Heritage Advisory Committee
July 23, 2008

SUBJECT: Case H00223: Substantial alterations to 1533 Barrington Street
(Masonic Hall), Halifax, a municipally registered heritage property

A2.0

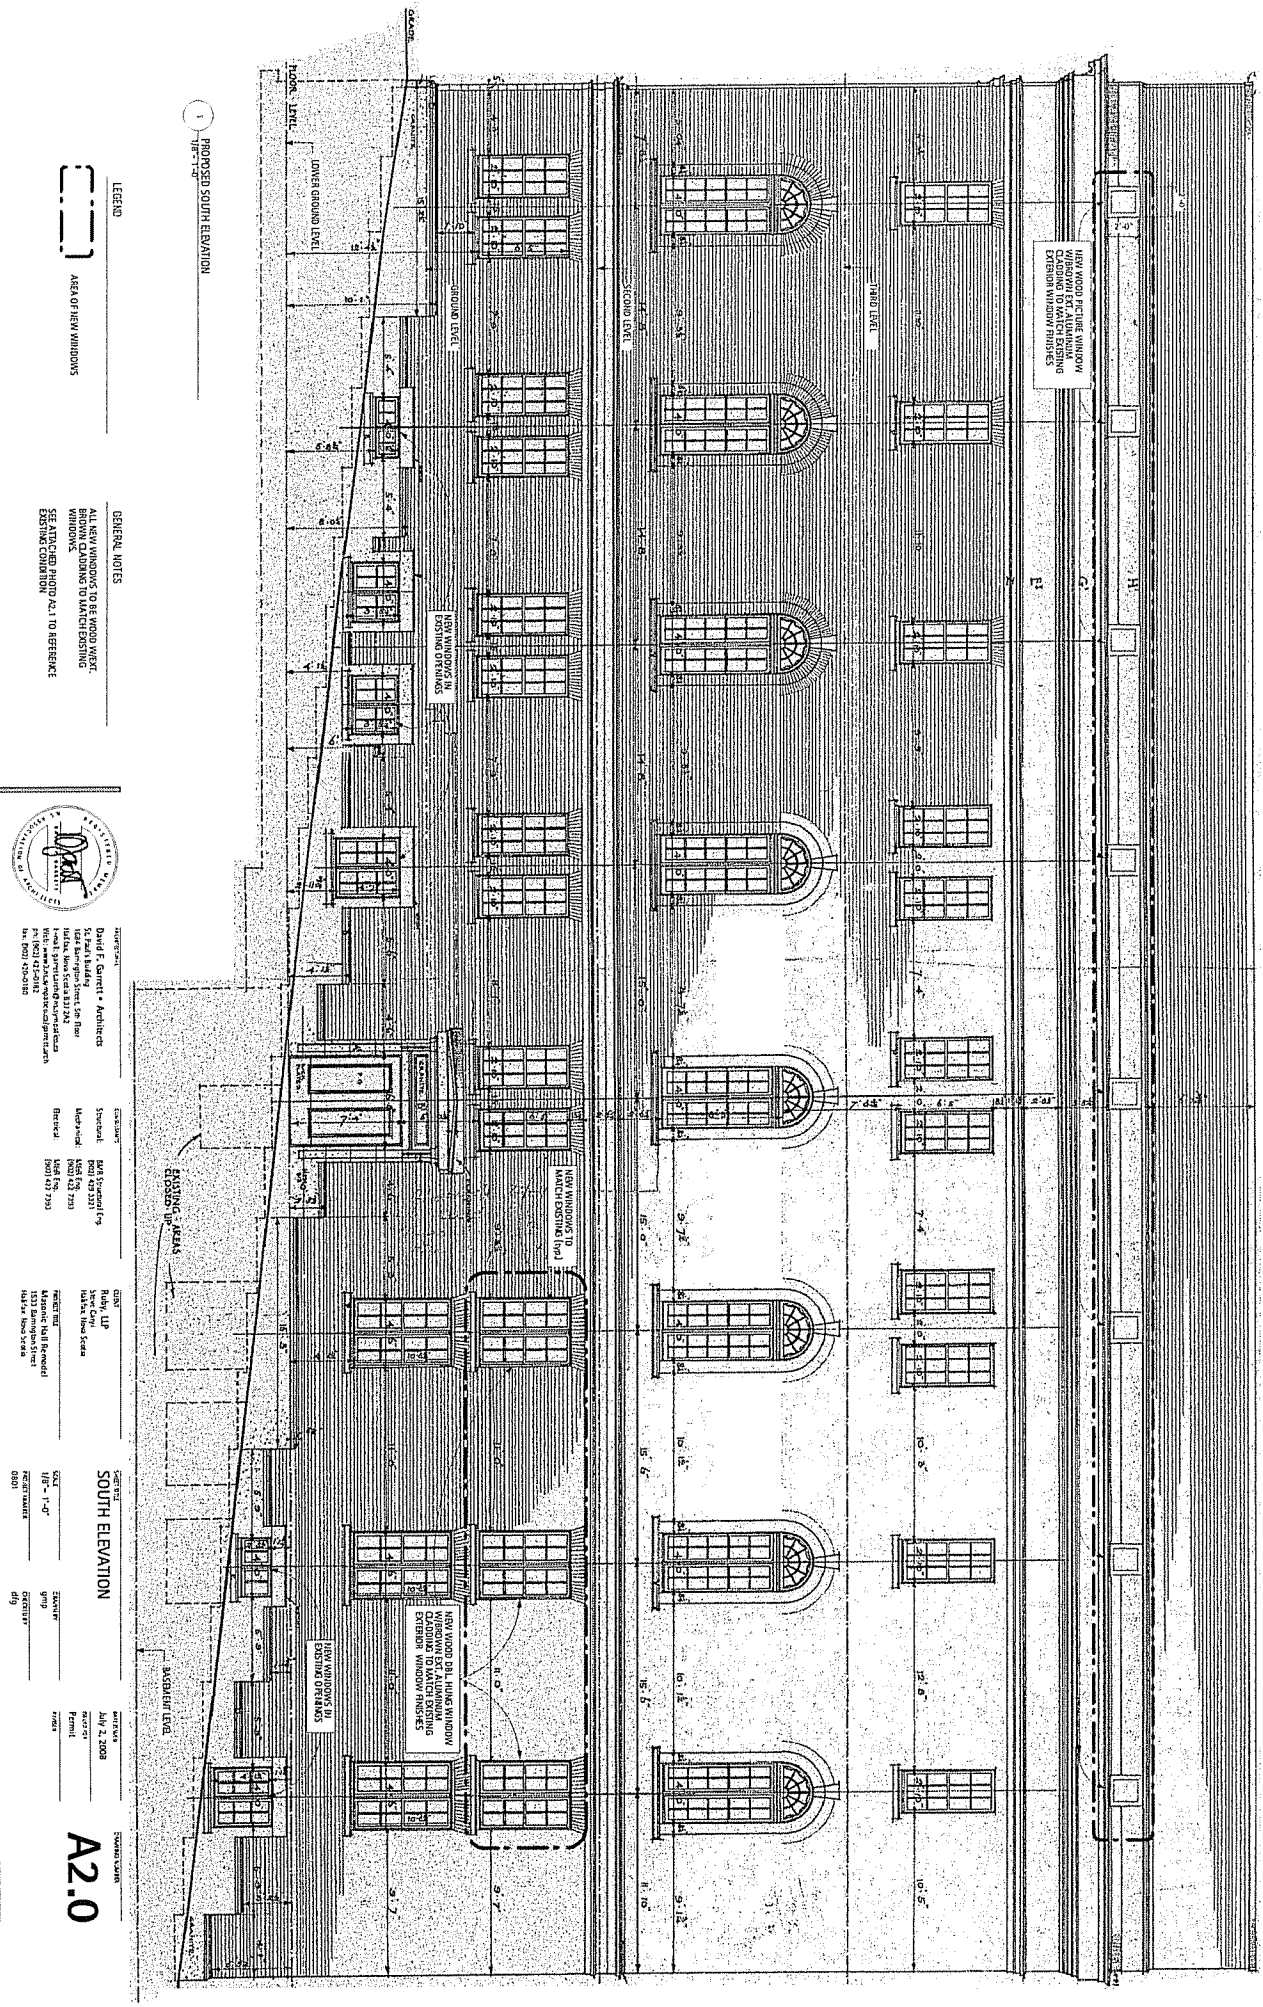
Side Elevation: Salter Street (see Attachment "C", drawings A2.0 and A2.1)

- The existing tall windows for the former Locas Bar space will have their openings extended upward to enable them to be divided into separate upper and lower windows to light the two new floors of office space into which the former bar space will be divided.

- The new windows will be aluminum clad wood windows, with brown colour to match the existing windows.
- Trim around the new windows will match existing window trim, with new sandstone sills and new soldier course brick lintels.

- Windows in the former storage area, to the left of the Salter Street entrance will also be replaced in their existing openings, again with aluminum clad wood units.

- On the top floor, a series of new, small, square window openings (2 ft. x 2ft.) will be created just above the cornice to light the new uppermost level of office space into which the Lodge rooms will be divided.

- All new windows will align with the existing windows and conform with the symmetry of the existing fenestration.

A2.2

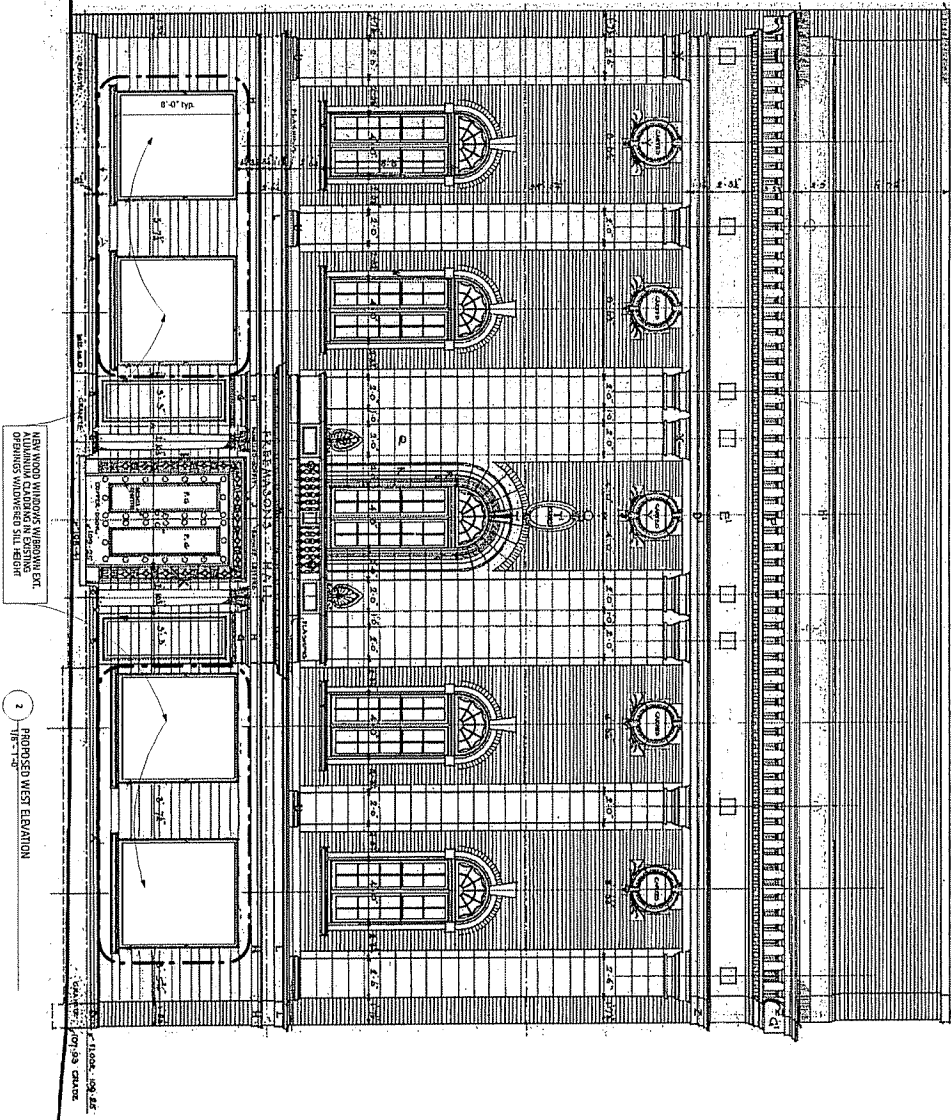
Front Elevation: Barrington Street (see Attachment "C" drawing A2.2)

- The street level display windows will have their sills lowered to enlarge the window opening slightly and enable greater retail display space. Existing sandstone sills will be re-used.
